## Product Change Notification

### *NVIDIA® Jetson AGX Xavier™ Products*

<b>PCN Number:</b>	CTIU-00040
<b>Revision:</b>	0.02
<b>Issue Date:</b>	2022-09-16
<b>Effective Date:</b>	2022-02-15

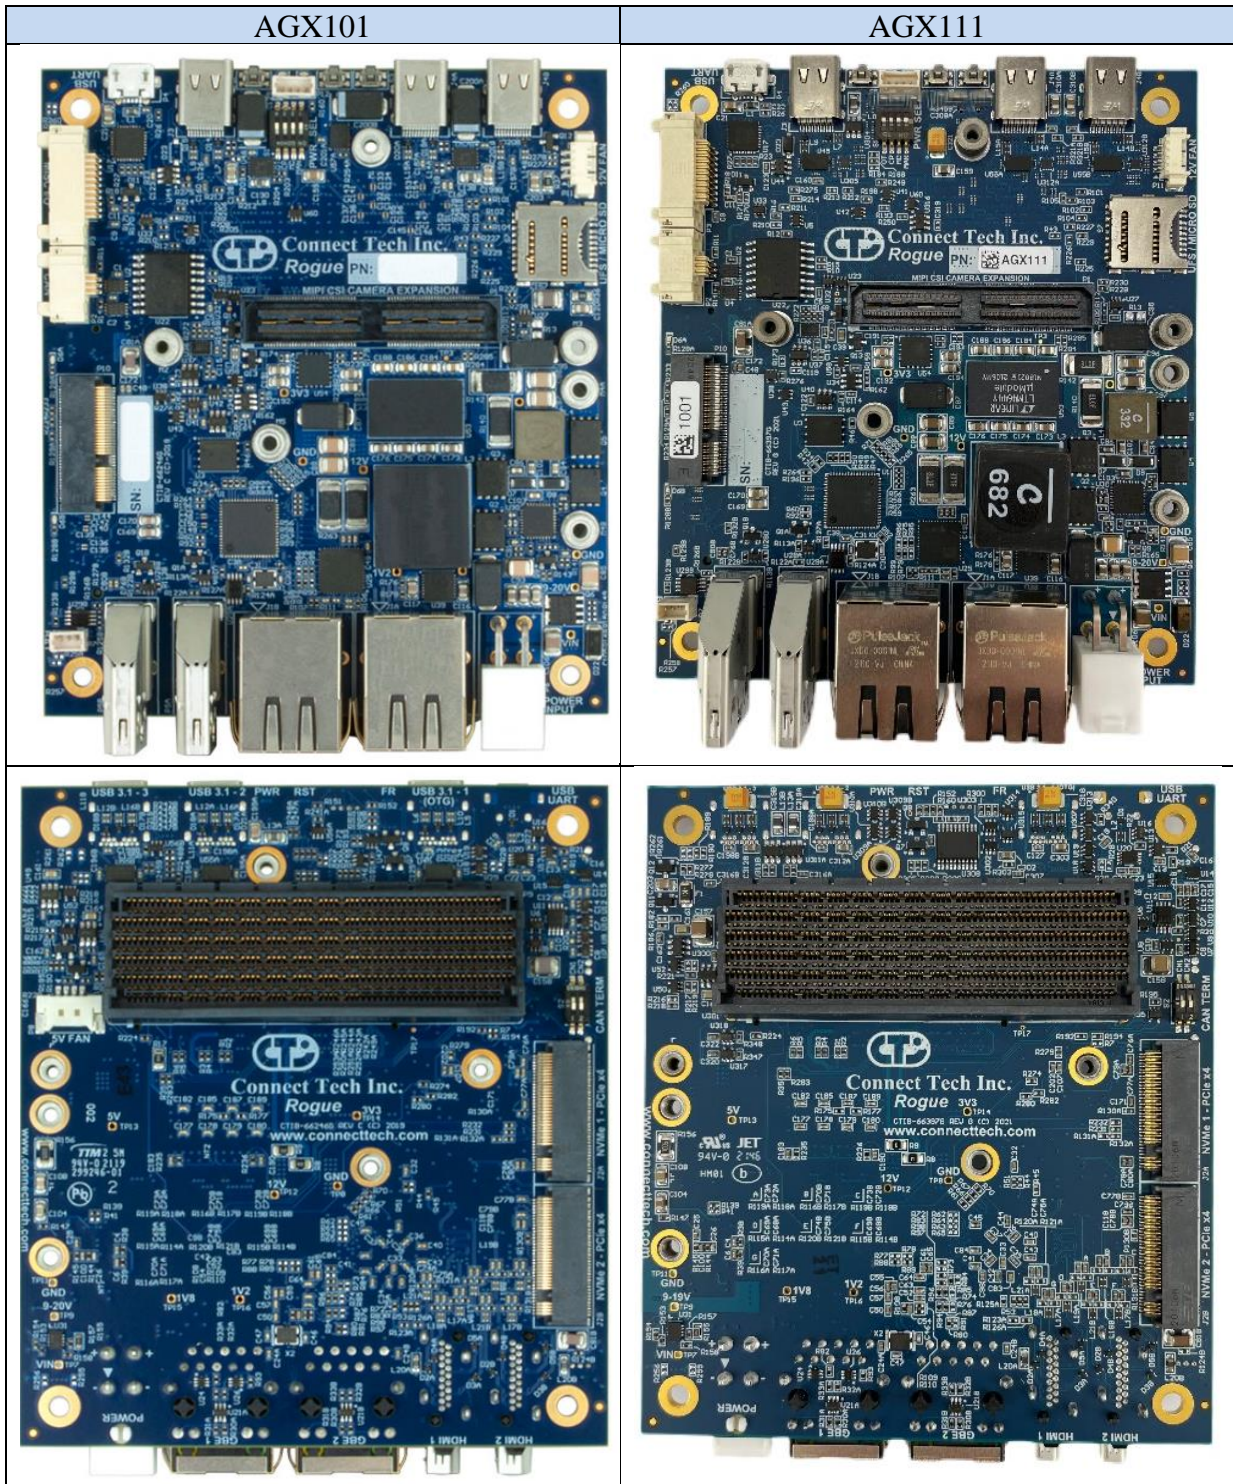
Carrier boards now support AGX and AGX Industrial Modules

## 4.4 Mechanical Compatibility

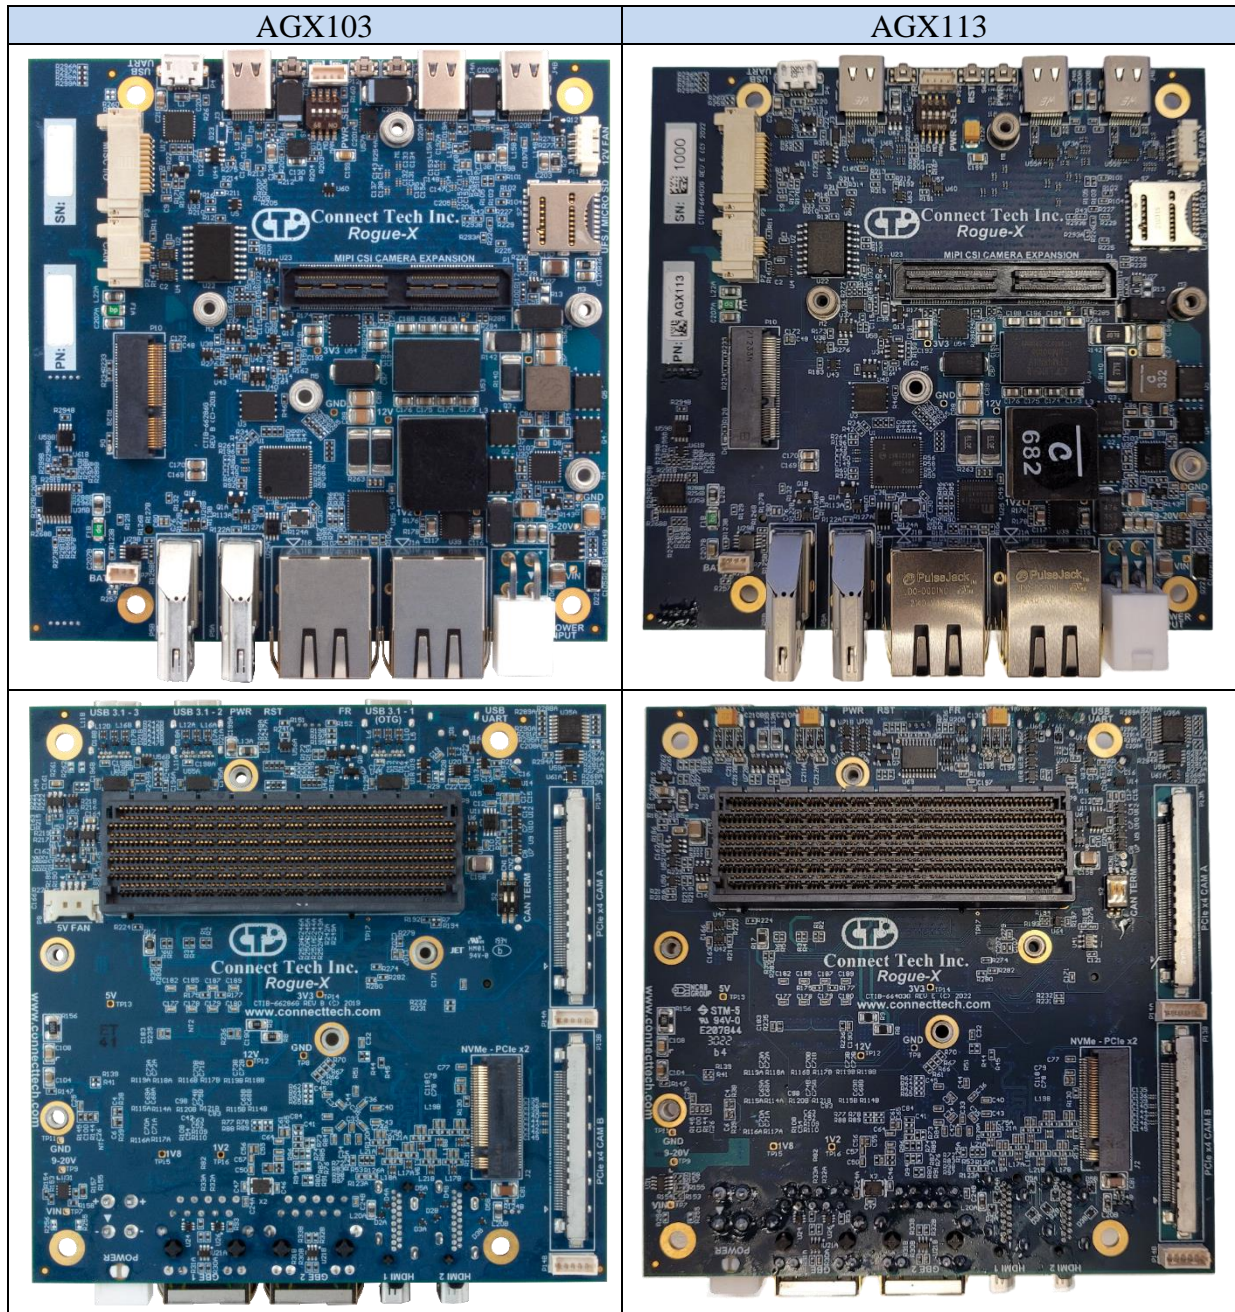
While the AGX111 and AGX113 are designed to be form fit and functionally equivalent to the originals; component placement has had to change to fit the alternate circuitry.

Ensure mechanical compatibility with end user designs by downloading new 3d models found on the CTI Website or by contacting [support@connecttech.com](mailto:support@connecttech.com).
